**Dugout Canyon Mine**

Re: Permit Revision Associated with Phase II Contemporaneous Reclamation Soils, Refuse Pile, Canyon Fuel Company, LLC, Dugout Canyon Mine, C/007/039

**Title:** Revision to M&RP - Phase II Contemporaneous Reclamation Soils at Refuse Pile

Refuse Pile Amendment  
February 2020

DRAWING OR  
MAP NUMBER  
RA Attachment 2-2

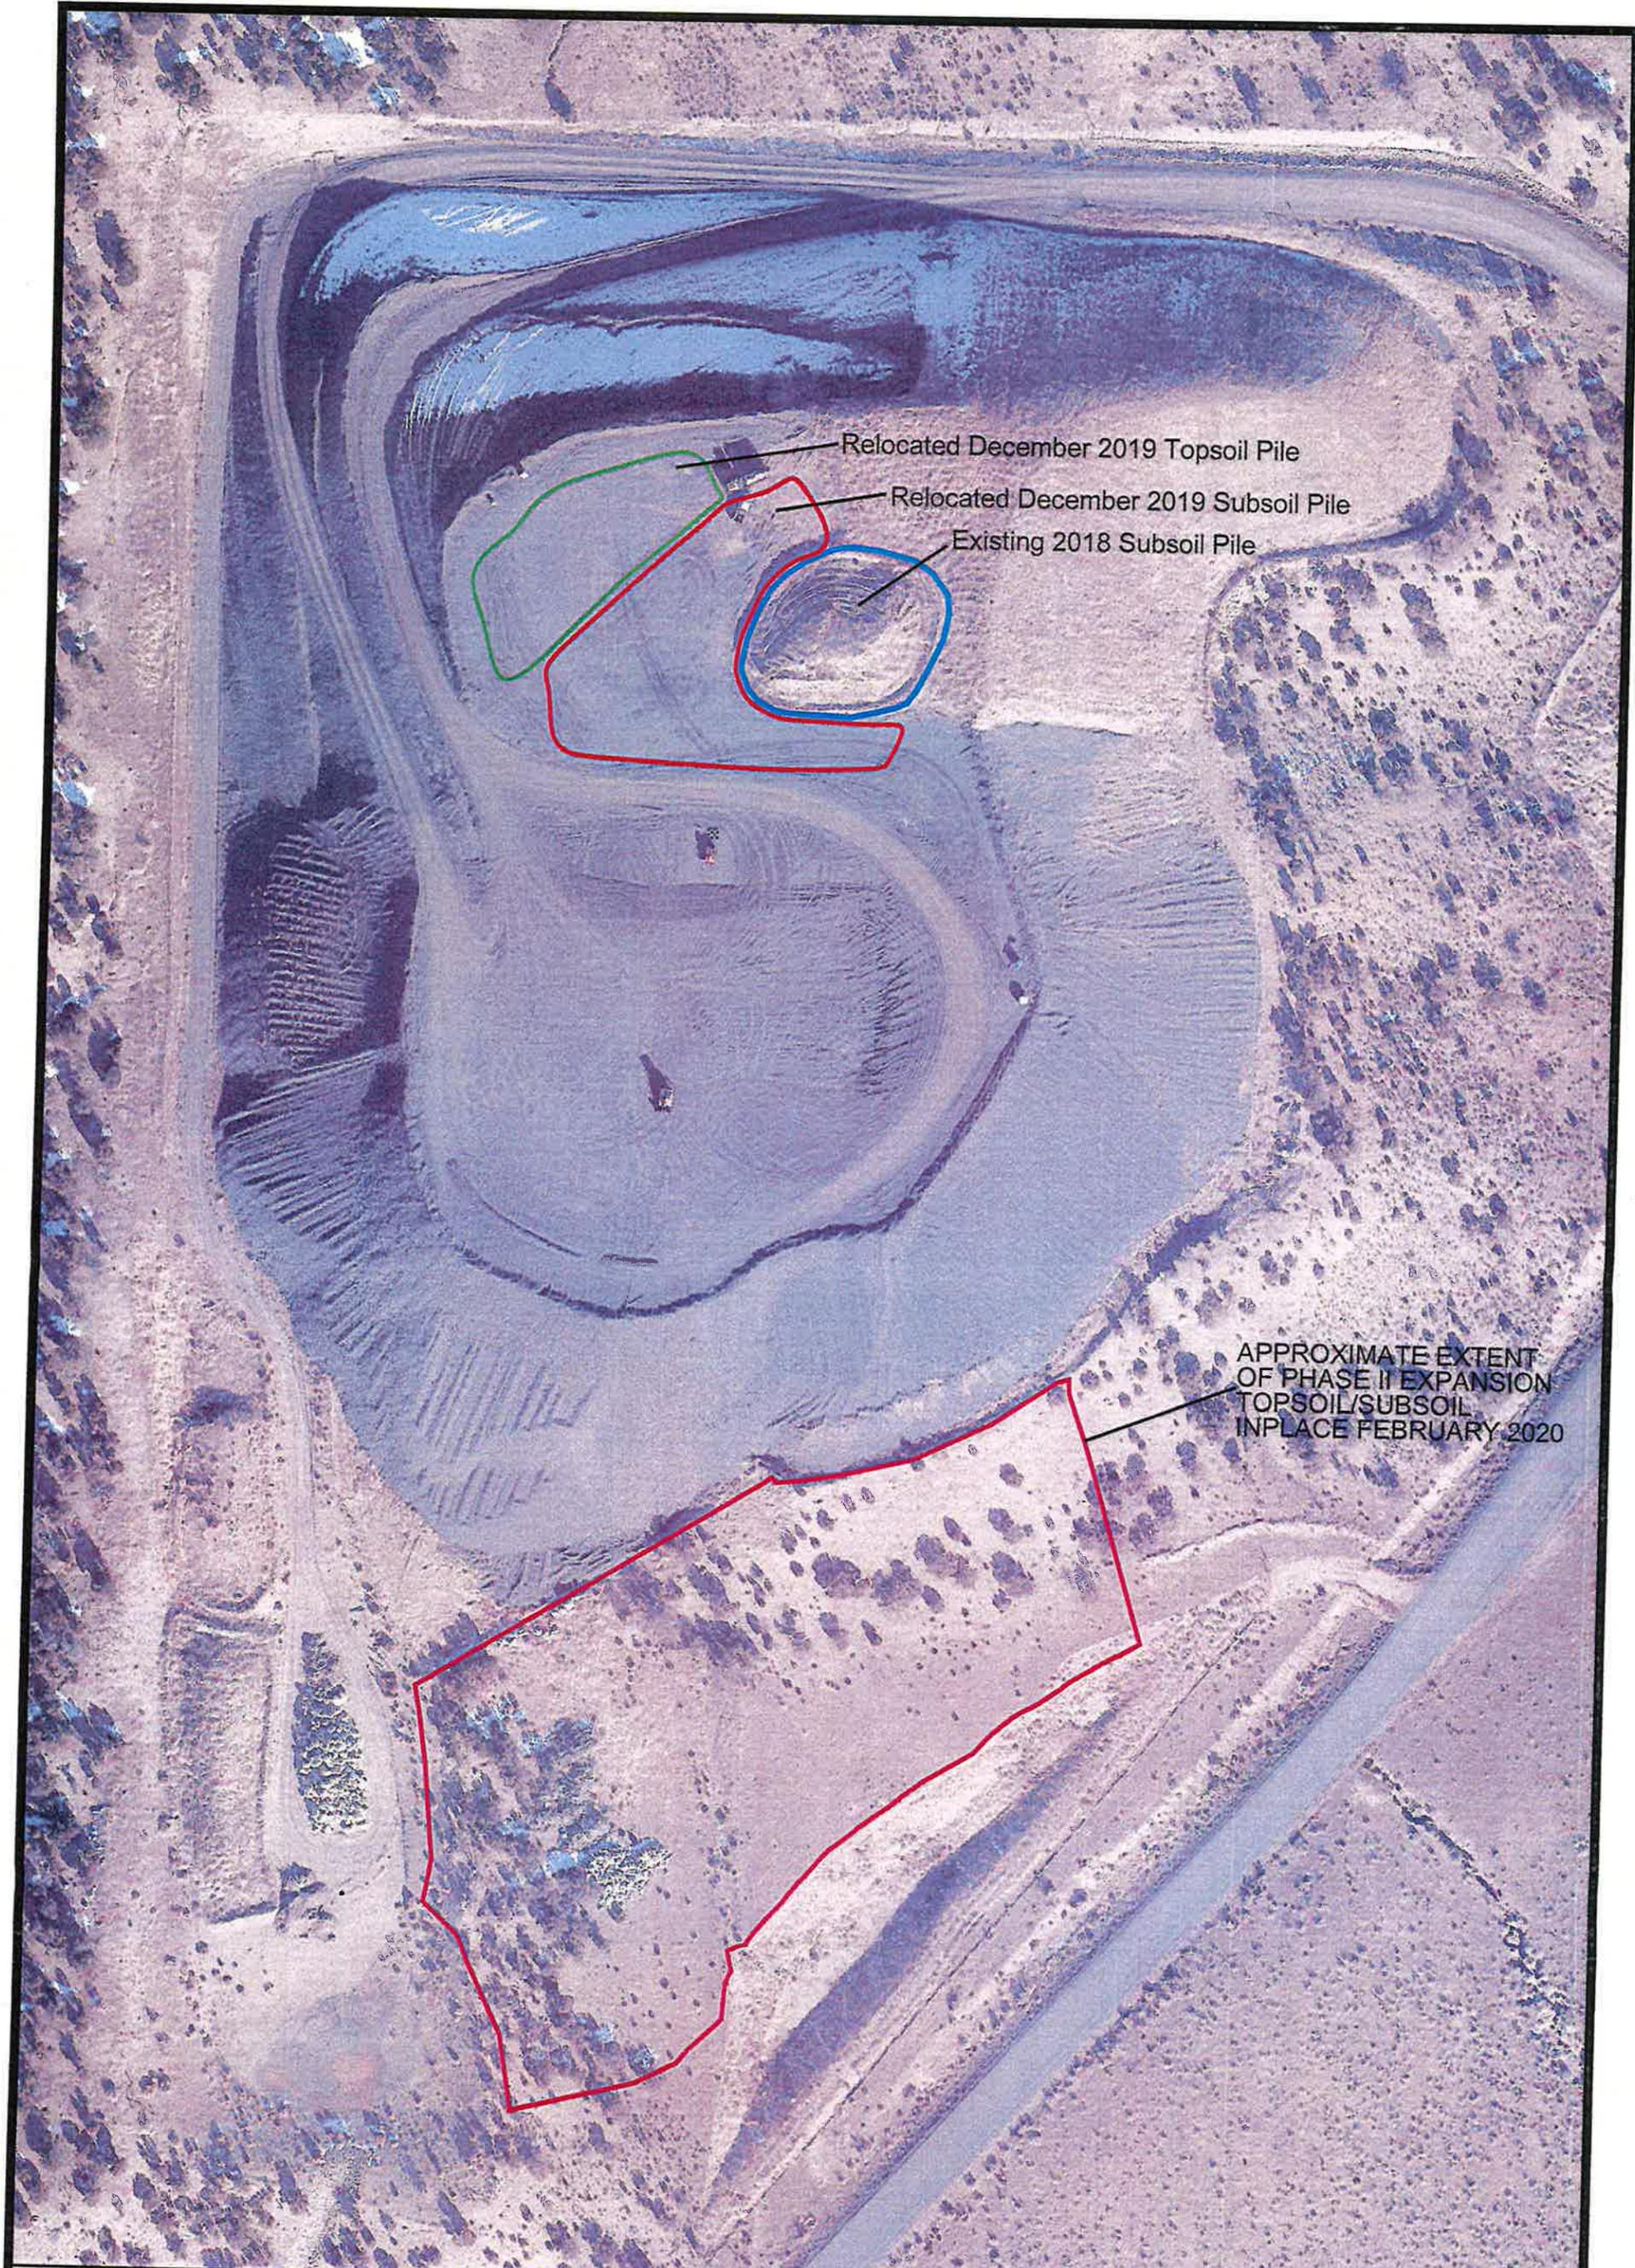
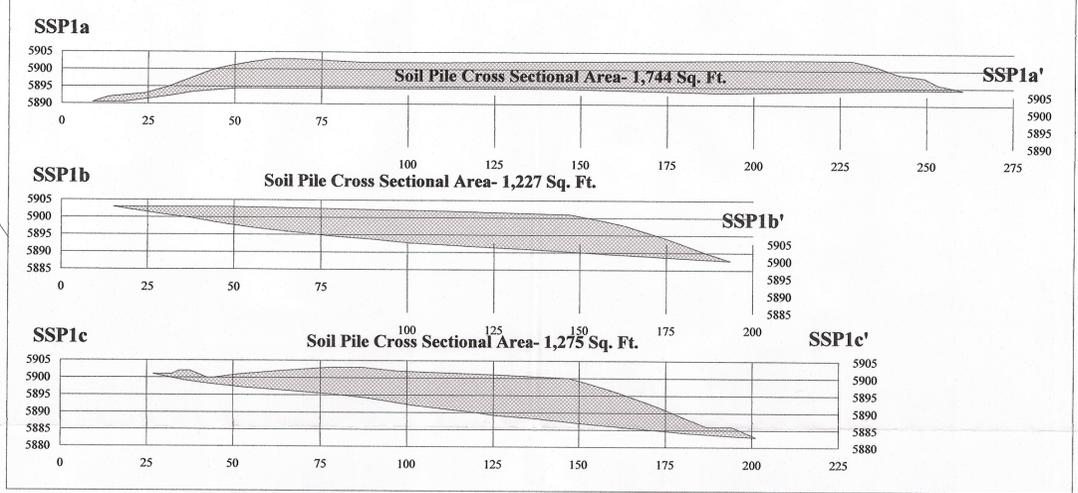
The drawing in this attachment illustrated the extent of topsoil and subsoil being temporarily piled atop the refuse pile. The soils will be used to continue the contemporaneous reclamation of the east facing slopes in 2020/2021. An approximate area of soils yet to be salvaged has been outlined. Refer to Section 242.100 for additional detail.

For Relocated Soil Quantities  
Refer To Section 242.100

DRAWN BY: STV/TAJ DATE: March 10, 2015 SCALE: 1" = 100'  
 APPROVED BY: DGS FILE NAME: RA Plate 2-2.DWG DRAWING OR MAP NUMBER: RA PLATE 2-2

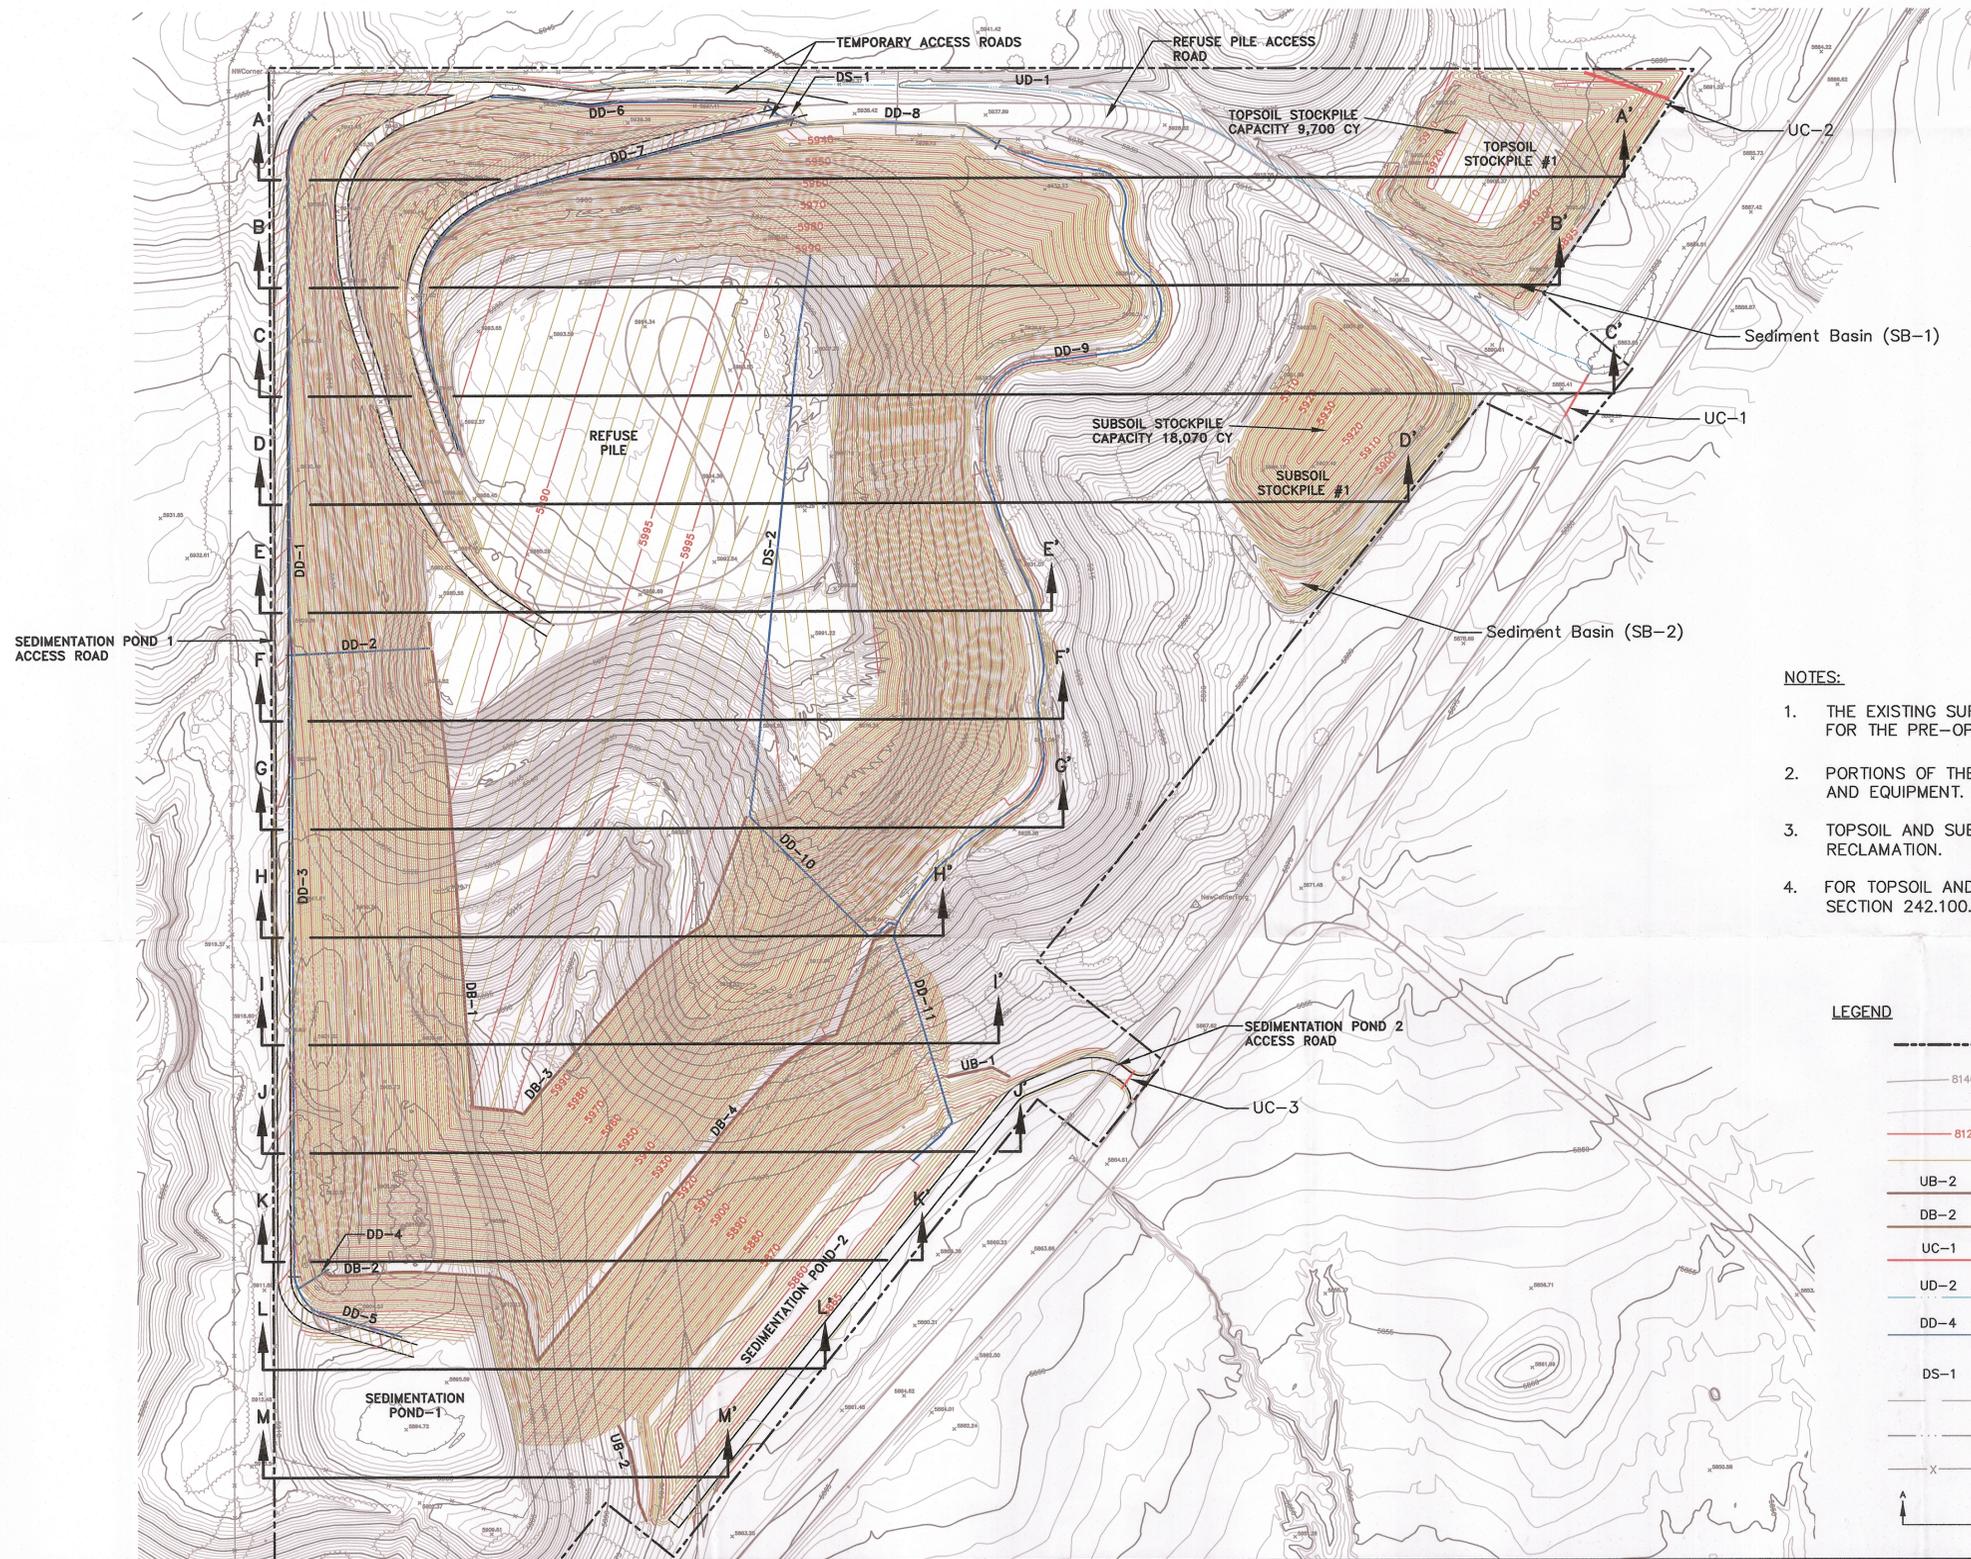
The contemporaneous reclamation will commence on the northeastern area of the refuse pile and will continue to the southern end of the pile as needed. See RA Plate 2-2 for more details.

During the southern expansion, contemporaneous reclamation will occur on the northeastern portion of the refuse pile. A two foot cover test plot will be designated in this area. See RA Plate 2-2 for the location.
